BWROG HUMAN FACTORS ENGINEERING - CONTROL ROOM SURVEY SUPPLEMENT

In response to recently formulated regulatory requirements for design reviews of nuclear power plant control rooms (NUREG-0660, NUREG-0700), Cleveland Electric Illuminating Company has undertaken a preliminary human factors evaluation of the Perry control panels. This one week review was performed by operations and engineering personnel from three utilities, two human factors consultants, and a representative from General Electric Company. General conclusions of the survey team are as follows:

PHOTO #1

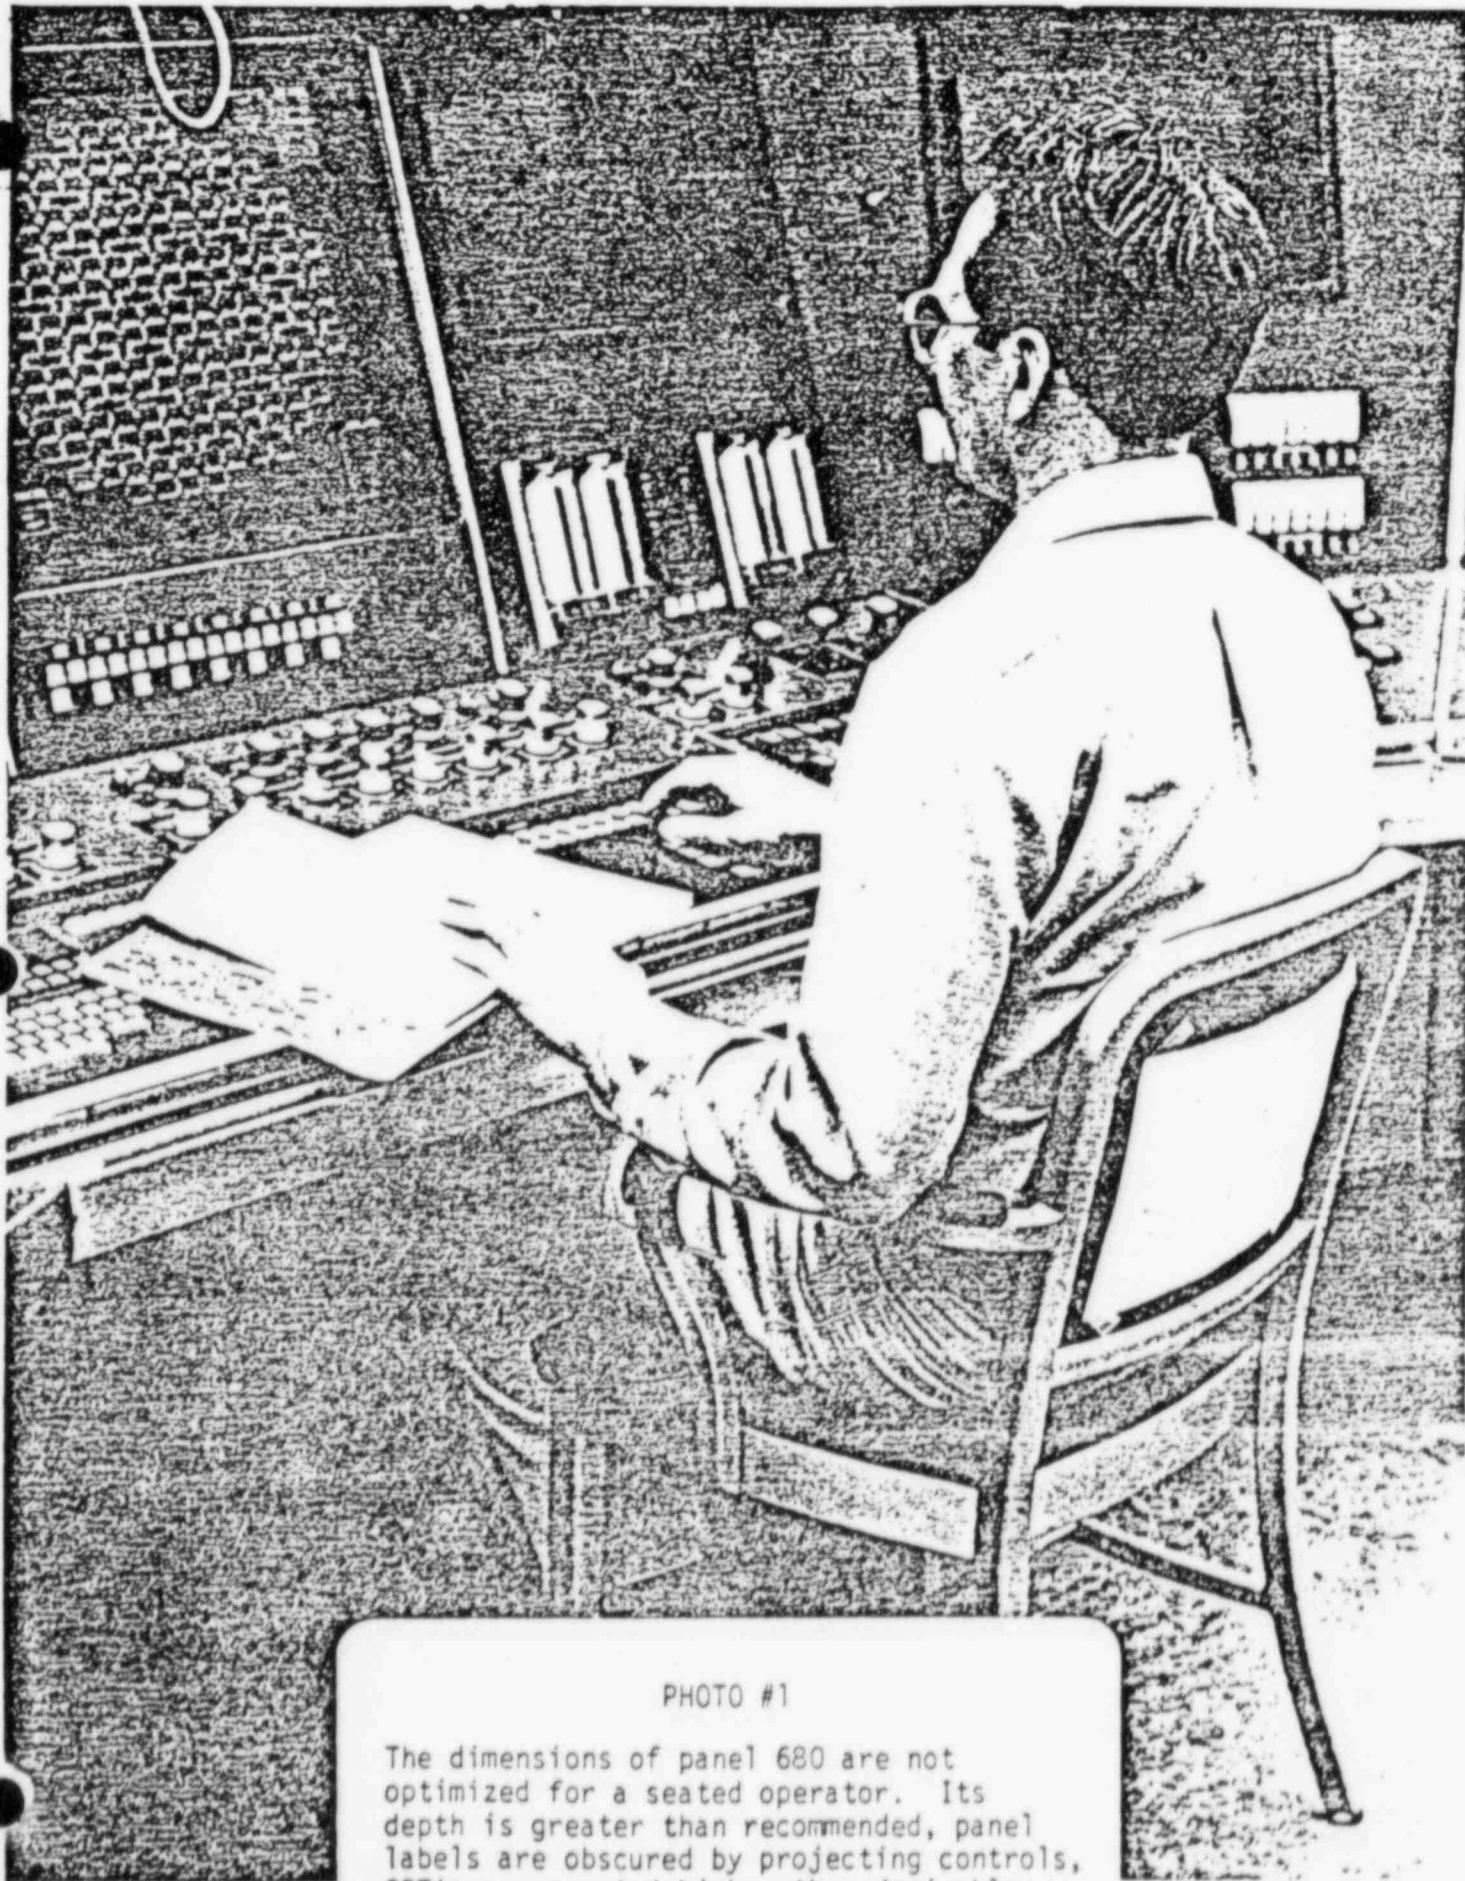
The dimensions of panel 680 are not optimized for a seated operator. Its depth is greater than recommended, panel labels are obscured by projecting controls, CRT's are mounted higher than desirable, and no procedure laydown space is provided.

PHOTO #2

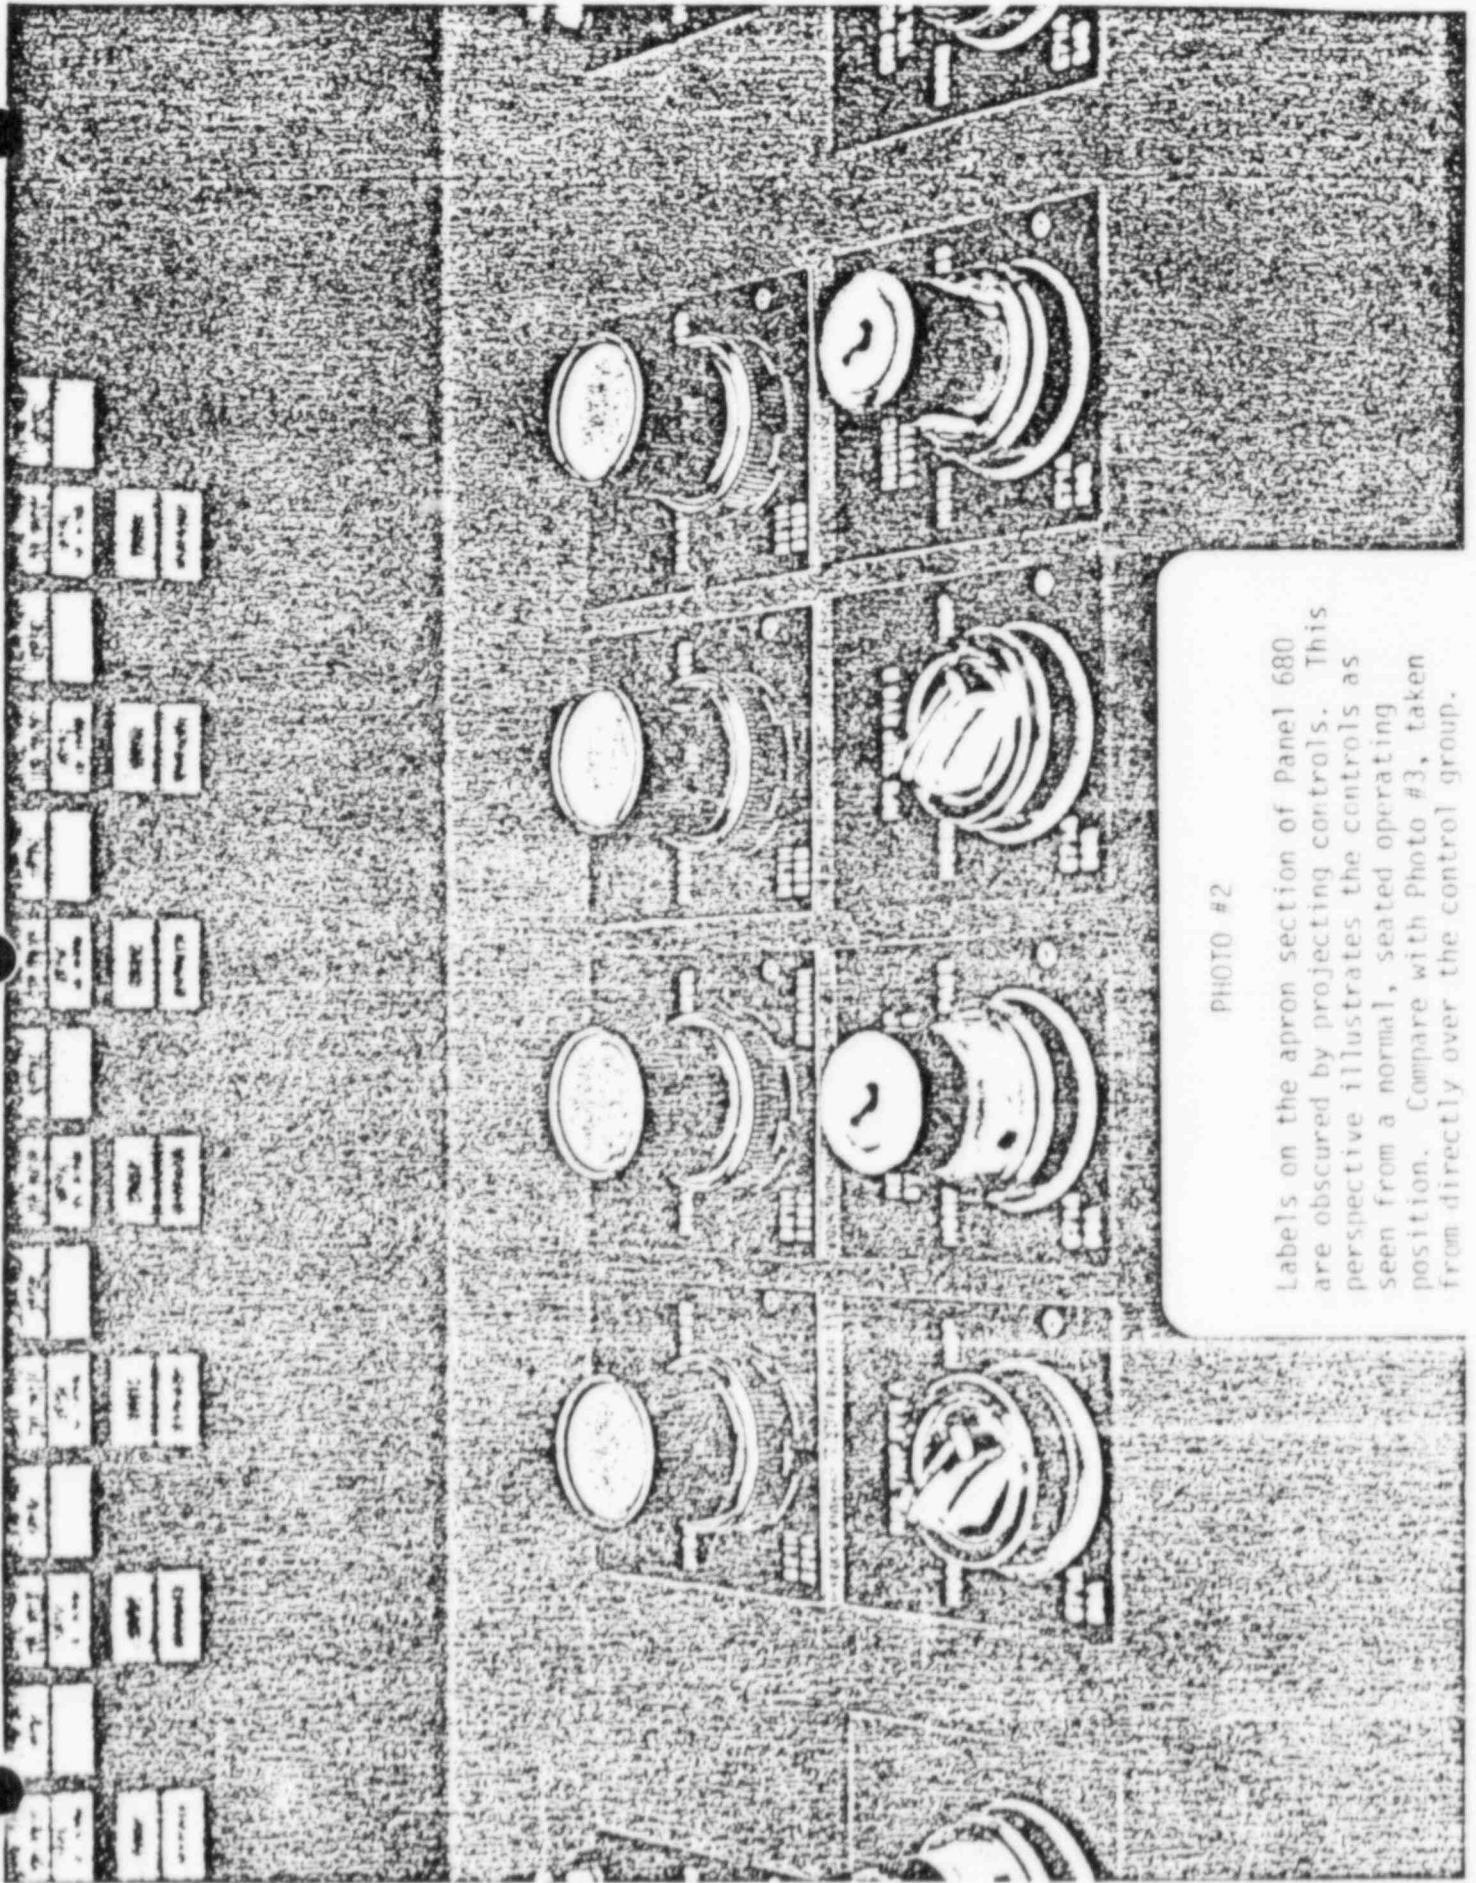
Labels on the apron section of Panel 680 are obscured by projecting controls. This perspective illustrates the controls as seen from a normal, seated operating position. Compare with Photo #3, taken from directly over the control group.

PHOTO #4

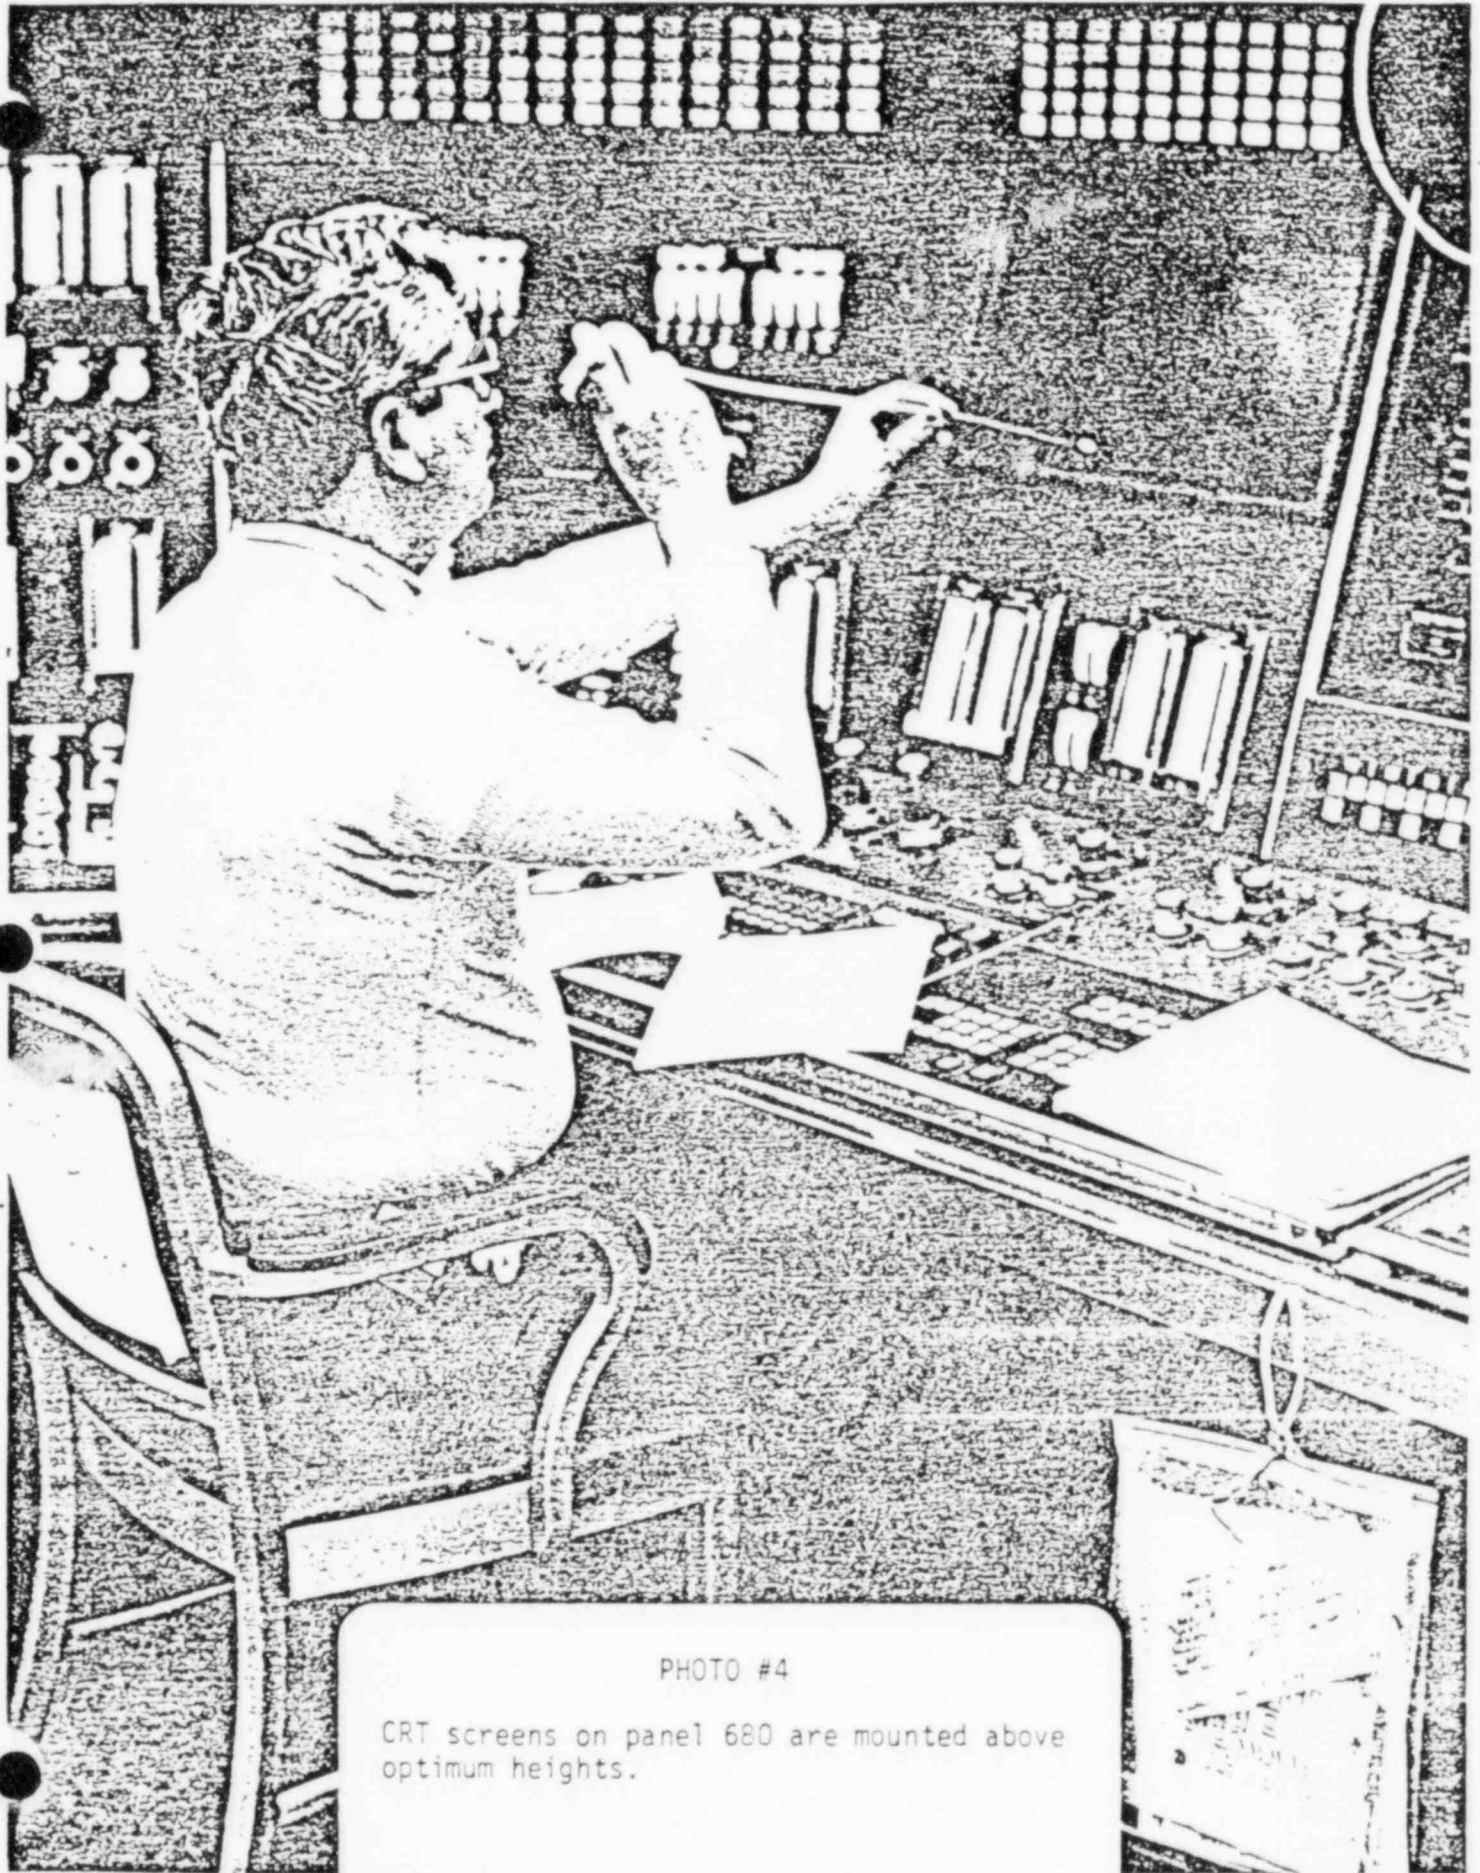
CRT screens on panel 680 are mounted above optimum heights.
